**ROGERS MS CENTRAL KITCHEN
A#03-124869
ADDENDUM 1 NARRATIVE**

AS REVISED
ADDENDUM 1
DSA #03-124869

LESD WILL ROGERS MS CENTRAL KITCHEN HVAC UPGRADES
LAWDALE ELEMENTARY SCHOOL DISTRICT
4110 W 154TH ST., LAWDALE, CA 90260

CONDENSATE DRAIN TO (E) LAV OR MOP SINK

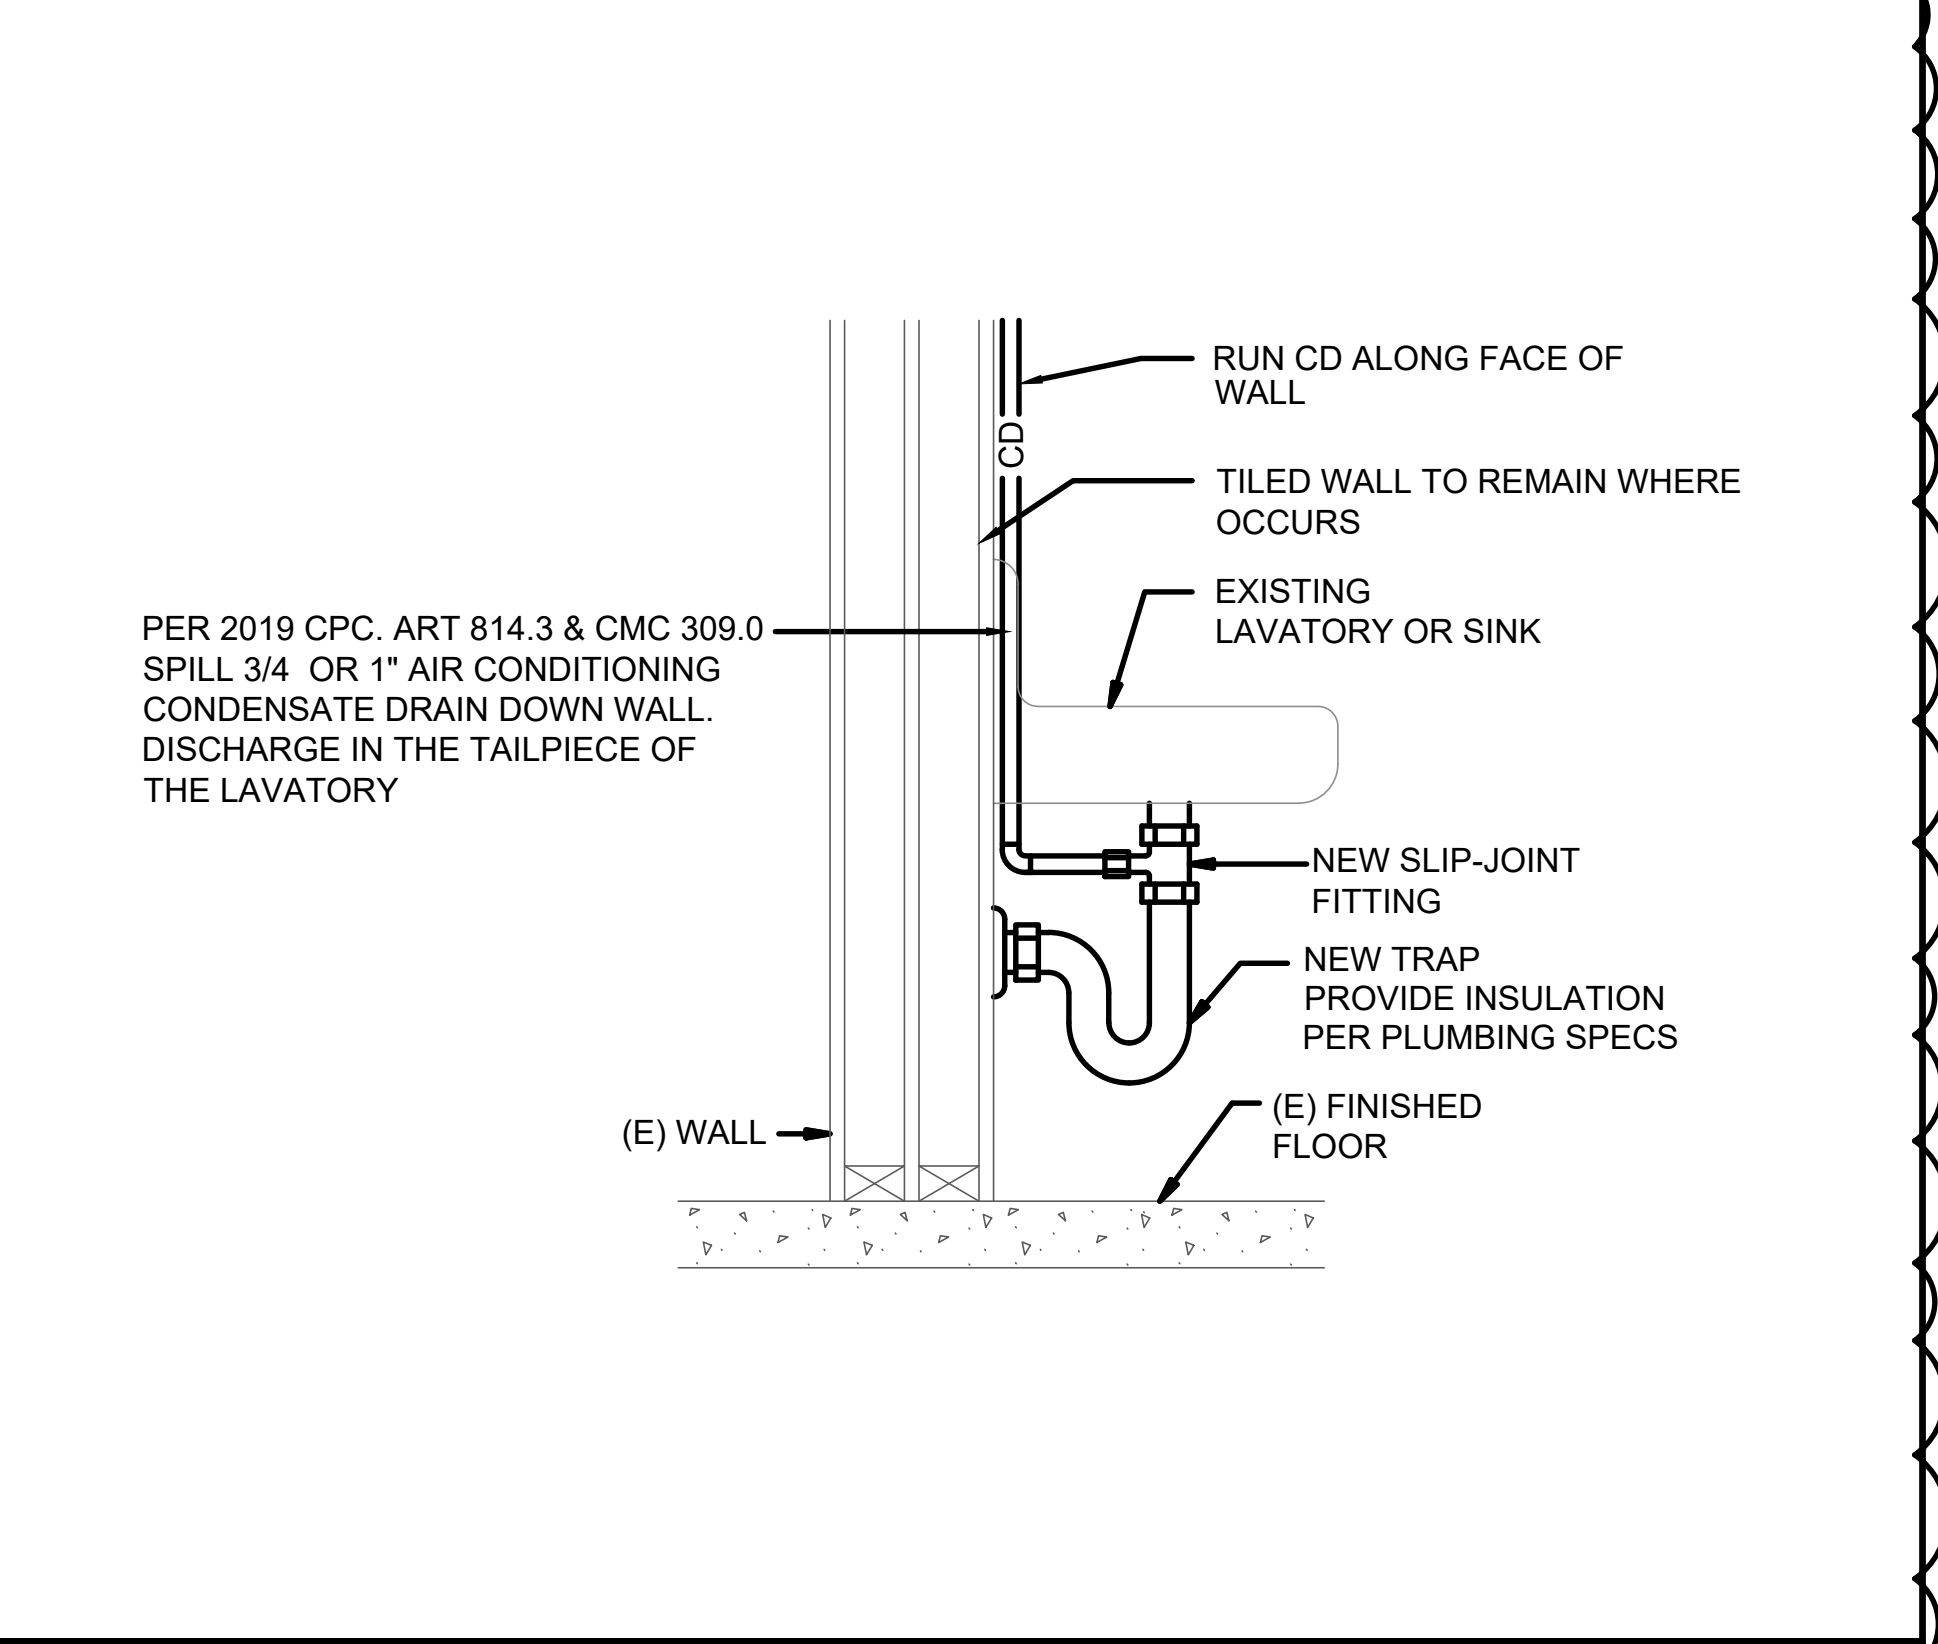
- a) Revised Detail 1 – FCU Condensate Removal Detail so the CD slope is revised and clarified the condensate pump.
- b) Revised Detail 3 to remove language referencing "Architect".
- c) Added Detail 4 - Condensate Drain to (E) Lav or Mop Sink.
- d) Revised Detail 6 - Outdoor Unit – CD Connection Detail so the draining method is simplified.
- e) Revised Detail 7 – Outdoor Unit Mounting Detail so the galvanized sheet metal pan is mounted directly to the concrete pad. Added note for scarification and clarified the drain pan and anchorage method.

WALL PIPING RISER DIAGRAM

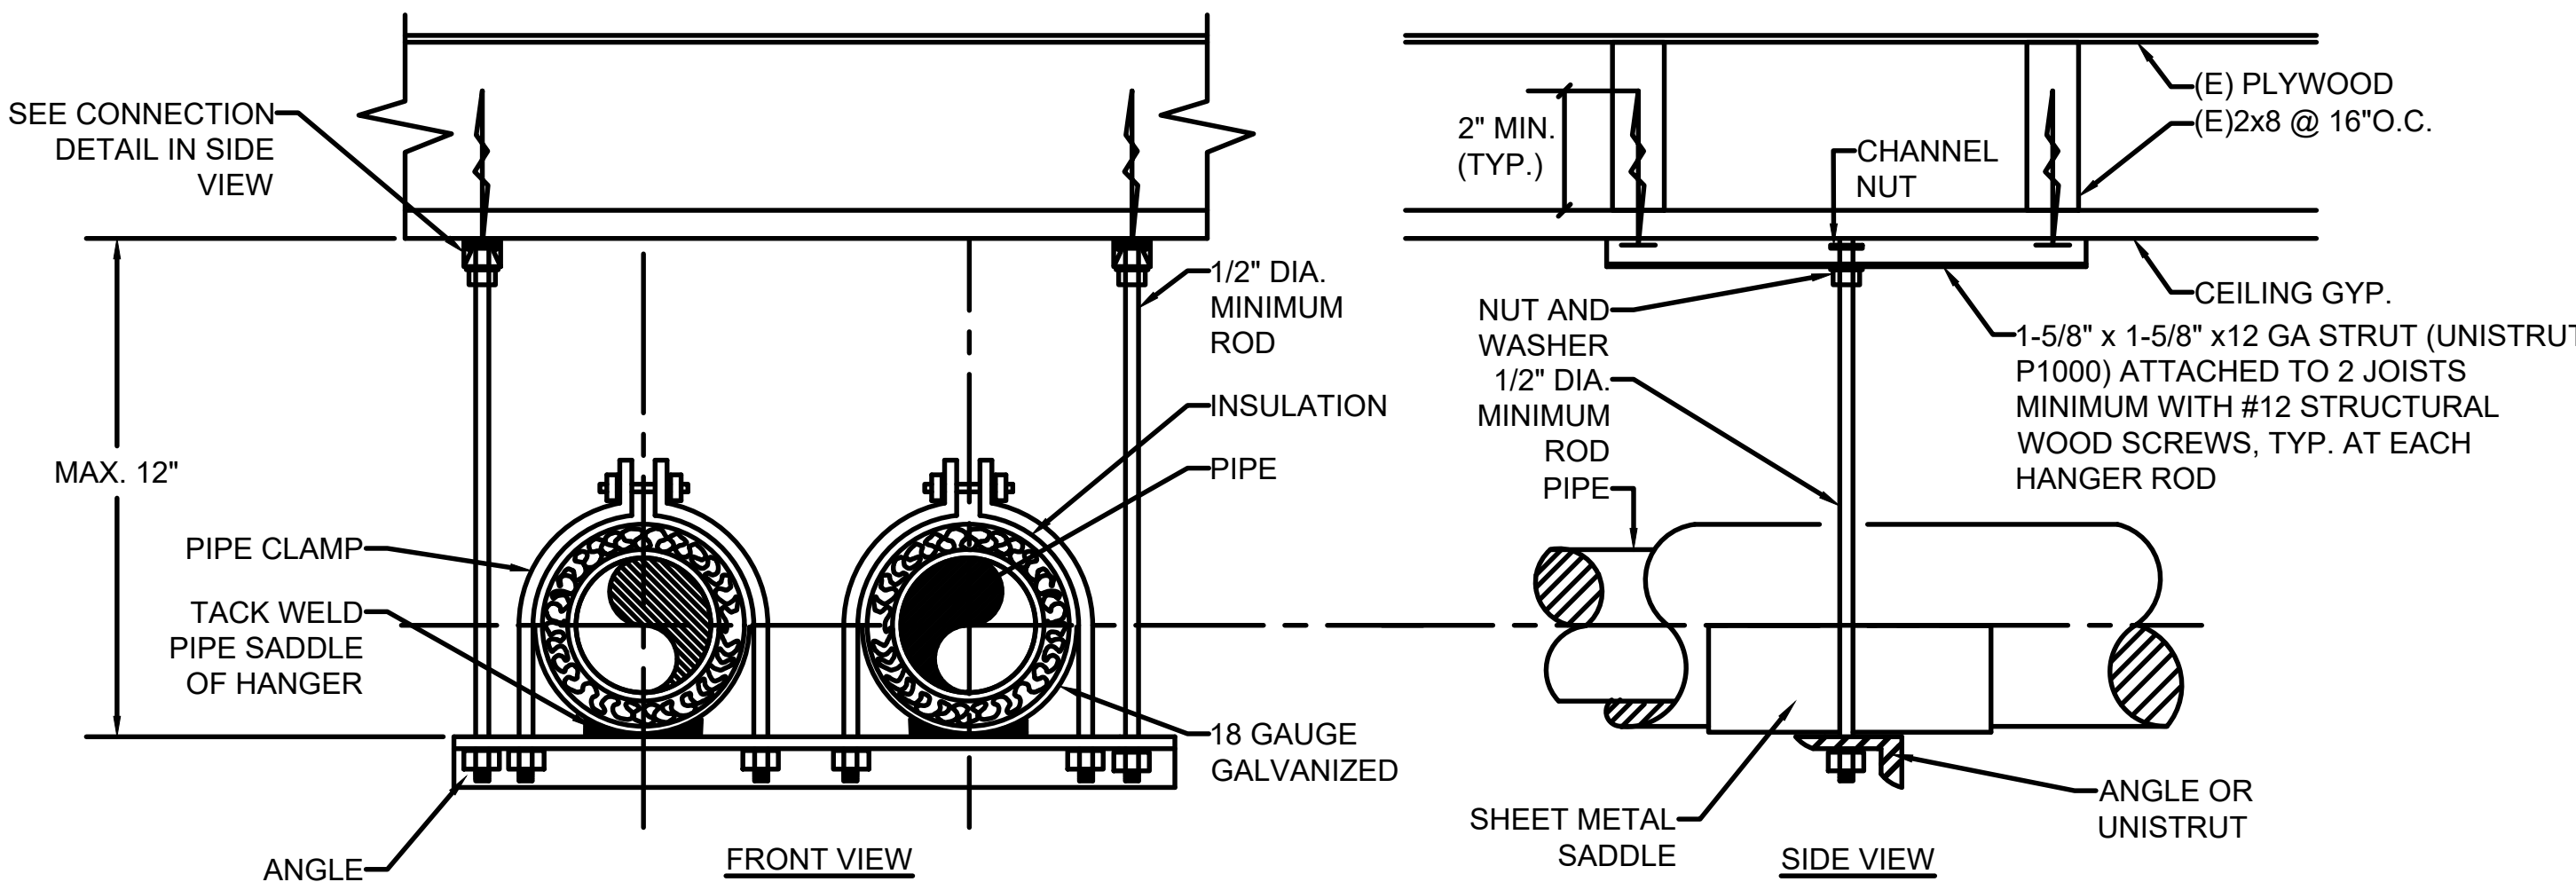
- a) Revised Detail 2 – Wall Piping Riser Diagram to clarify the spacing between the pipes.
- b) Revised Detail 5 – Split System Installation Detail to remove sheet metal cap and to remove the "slope towards drain" language for the sheet metal pan. Added note to clarify condensate pump.
- c) Revised Detail 6 – Condensate Drainage Drywell to add language for "Traffic Rated".

PIPING THROUGH ROOF DETAIL

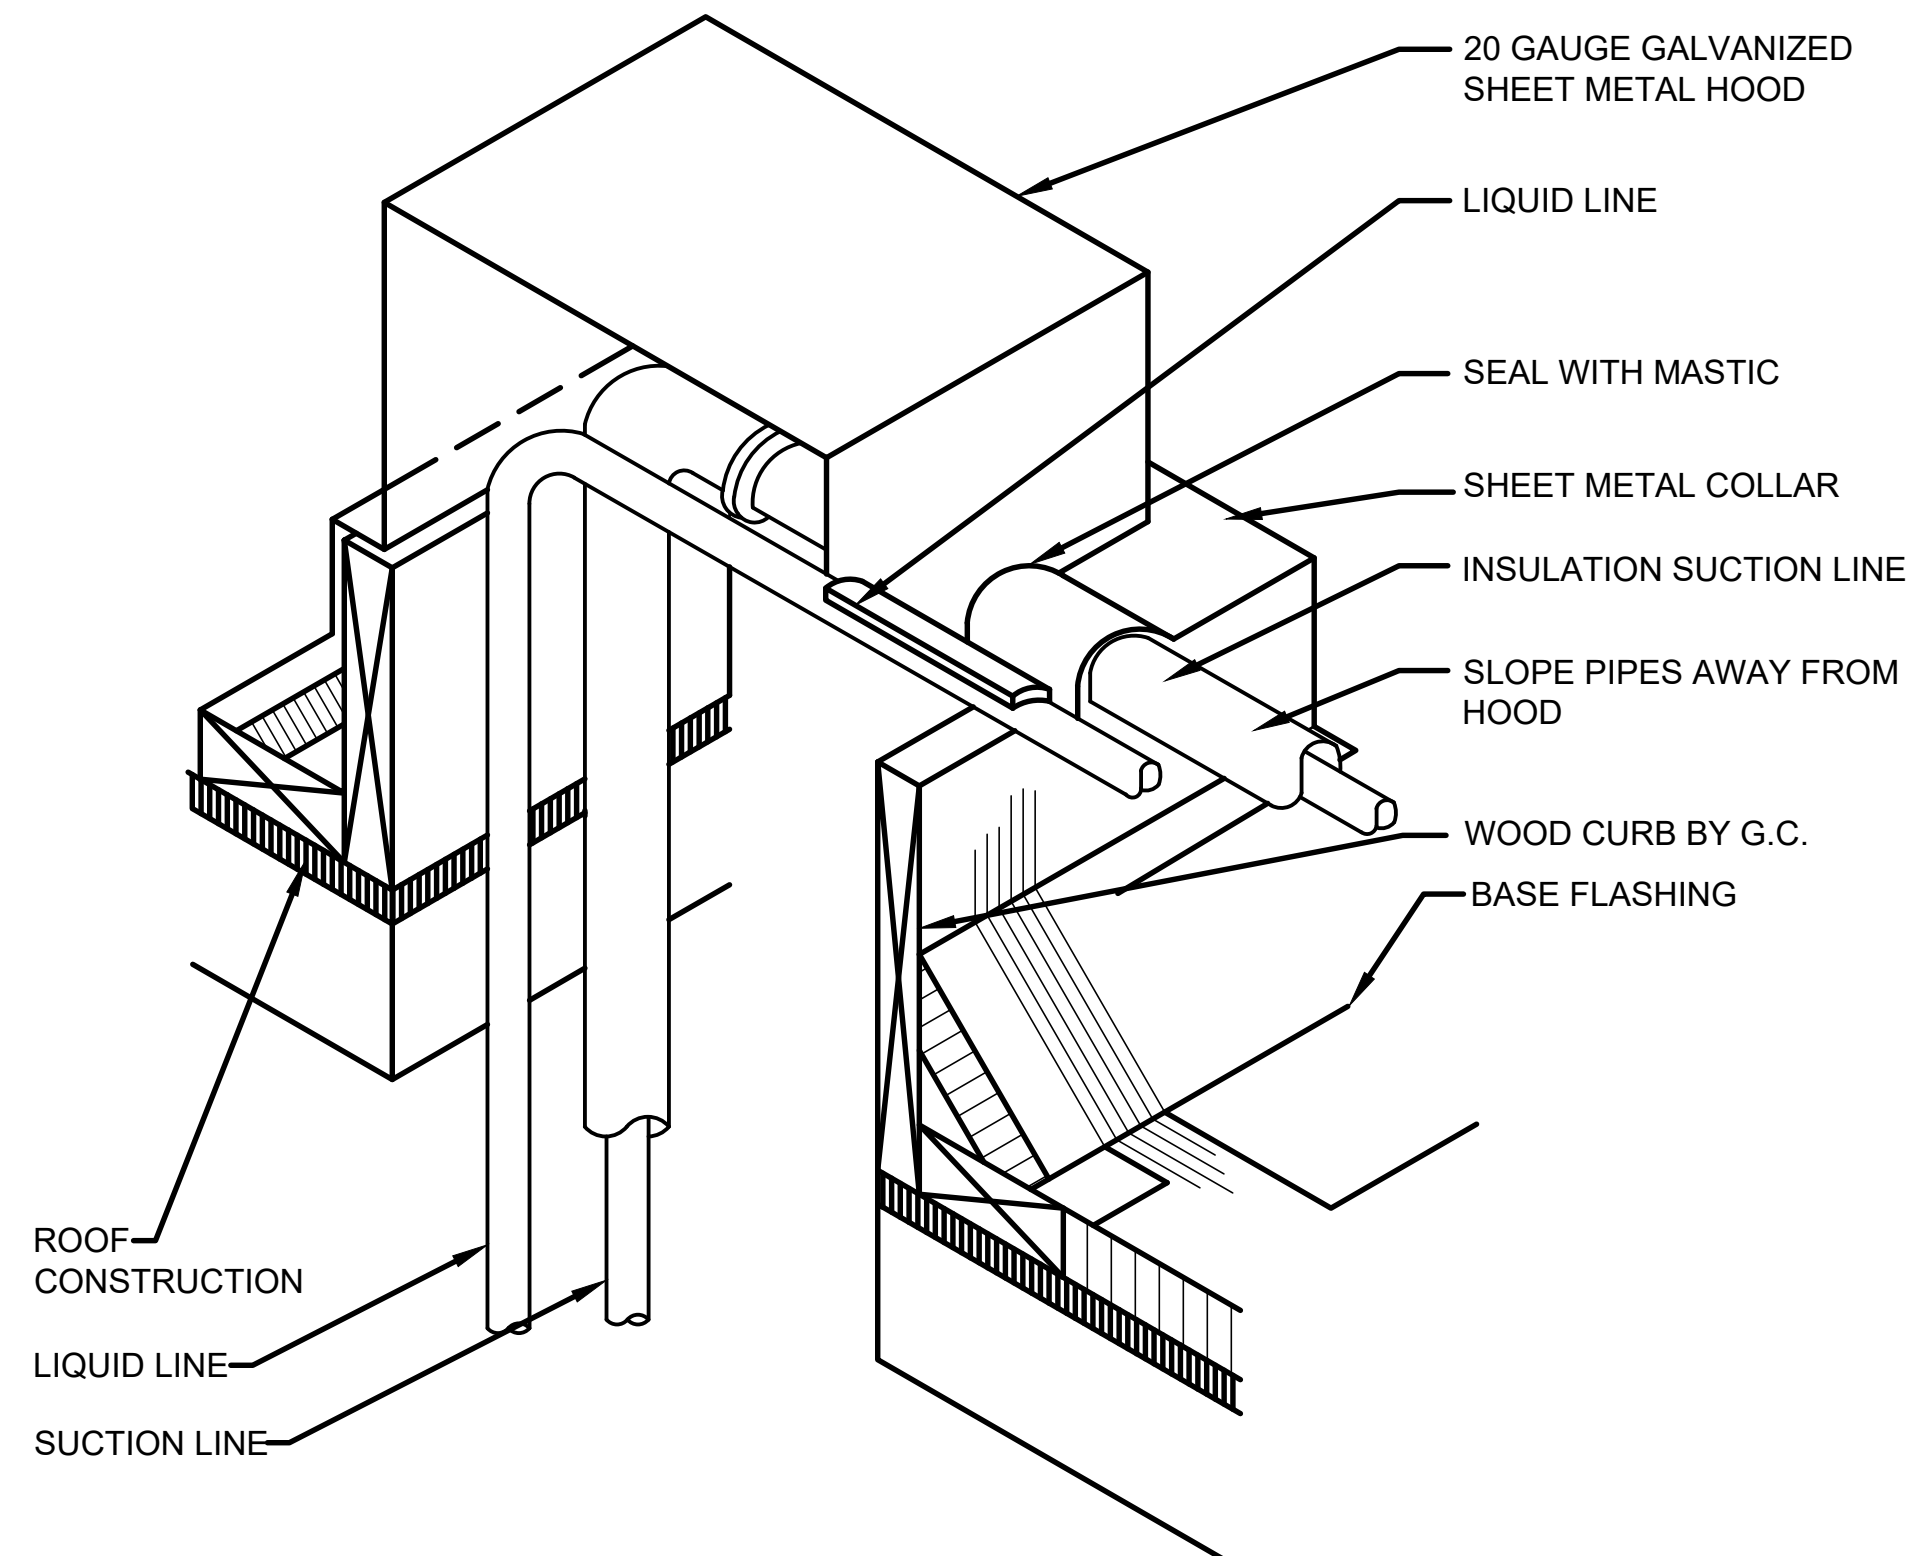
- a) Added Detail 2 – Fan Coil Condensate Connection Detail to indicate the condensate drainage for gravity draining the fan coils.
- b) Added Detail 3 – Piping Through Roof Detail for refrigerant piping through the roof.
- c) Added Detail 4 – Roof Mounted Exhaust Fan Detail for new exhaust fan 118 that will be placed where the existing relief vent hood is currently located – note that existing curb shall remain.
